## Model Error Resolution Document

1. Document Number:	ANL-EBS-MD-000037	2. Revision/Addendum:	04/01	3. ERD:	02
4. Title:	In-Package Chemistry Abstraction				
5. No. of Pages Attached:	Attachment A: 3 pages; Attachment B: 3 pages

**ATTACHMENT A****ANL-EBS-MD-000037 ERD 02 Corrections****A.1 Corrections in Response to CR 12448**

Figure 6-1[a]. CSNF Degradation Rate per Liter of Water (Lw) in the Liquid Influx Model

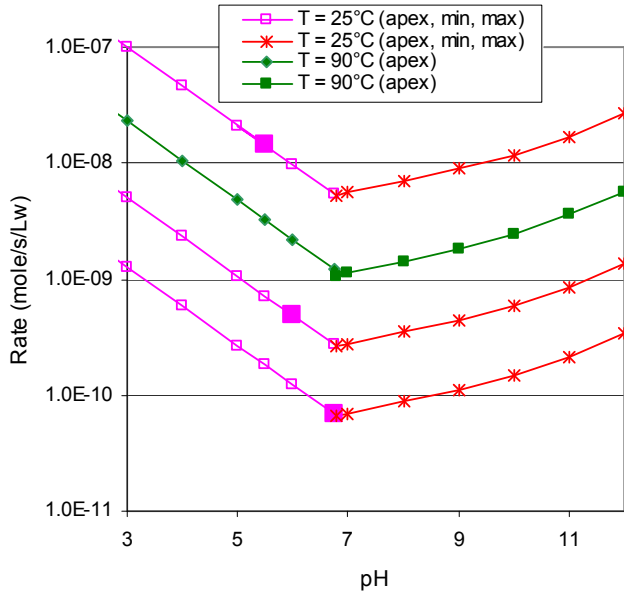
**A.1.1 Figure 6-1[a]**

The errors identified in Figure 6-1[a] are due to an error in the equilibrium constant used in column R of worksheet "CSNF Rate" of spreadsheet "Rates CSNF Cell 1.xls" in revision 002 of Output DTN: SN0702PAIPC1CA.001. According to the data0.ymp.R5 database (DTN: SN0612T0502404.014 [DIRS 178850]), the log of the equilibrium constant should be 7.81, not 6.34, for the reaction  $\text{HCO}_3^- + \text{H}^+ = \text{CO}_2(\text{g}) + \text{H}_2\text{O}$  at 25°C. Output DTN: SN0702PAIPC1CA.001 was revised to correct this error. In addition, the 90°C calculations were improved in the worksheet in the DTN revision. Instead of using the 25°C equilibrium constants as approximations for the 90°C constants in columns R and S, more accurate constants for the reactions at 90°C, estimated by linear interpolation of the 60°C and 100°C data in the data0.ymp.R5 database, were incorporated, as documented in revision 003 of Output DTN: SN0702PAIPC1CA.001.

1. In Section 6.3.1.3.4[a] on p. 6-13[a], replace Figure 6-1[a] with Figure 6-1[a] of this ERD.
2. In Section 6.3.1.3.4[a] on p. 6-11[a] in the second full paragraph, remove the statement: "The discontinuities at pH 6.8 are due to the fitting functions used in the source."
3. In Section 6.3.1.3[a], in the notes of Tables 6-2[a], 6-3[a], and 6-7[a], and Figure 6-1[a], "Rates CSNF Cell 1.xls" is cited. Replace each citation with "Rates CSNF Cell 1 r003.xls".
4. In Sections 6.3.1[a], 6.5[a], and 6.6[a] there are seven locations (pages 6-7[a], 6-14[a], 6-22[a], 6-30[a], 6-34[a], 6-41[a], and 6-45[a]) where "IPC file key revision 2.xls" is cited. Replace each citation with "IPC file key revision 3.xls".

Figure 6-18[a]. 2MCO Liquid-Influx pH over Time for Various Seepage Compositions at 10<sup>-4</sup> bar CO<sub>2</sub>(g)

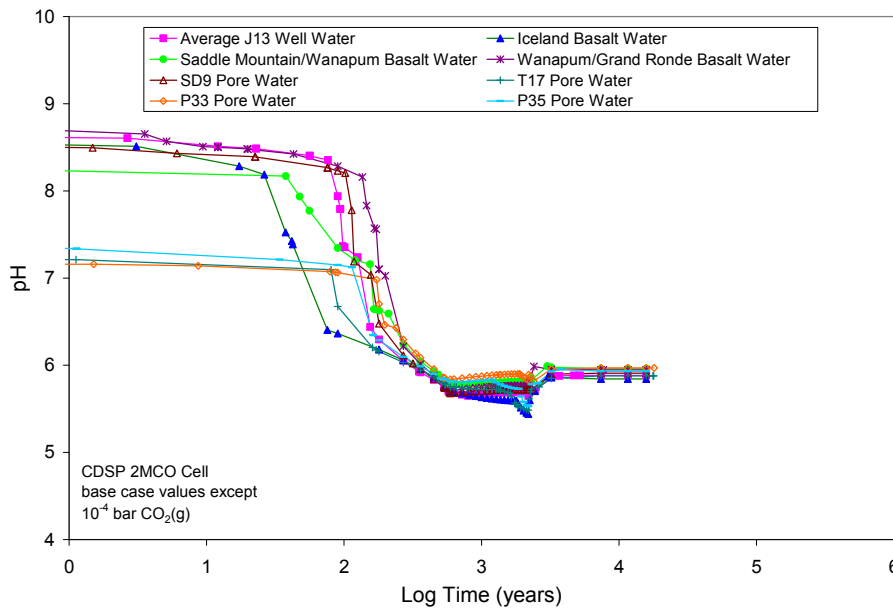
**A.1.2 Figure 6-18[a]**

In Section 6.6.3[a] on p. 6-37[a], the lower left corner of Figure 6-18[a] contains text that indicates it represents results for the CSNF 2MCO Cell. This is a typographical error. The

correct CDSP designation is documented in the source file. Replace "CSNF" with "CDSP" as shown in Figure 6-18[a] of this ERD. This change has no impact, as indicated in Attachment B.
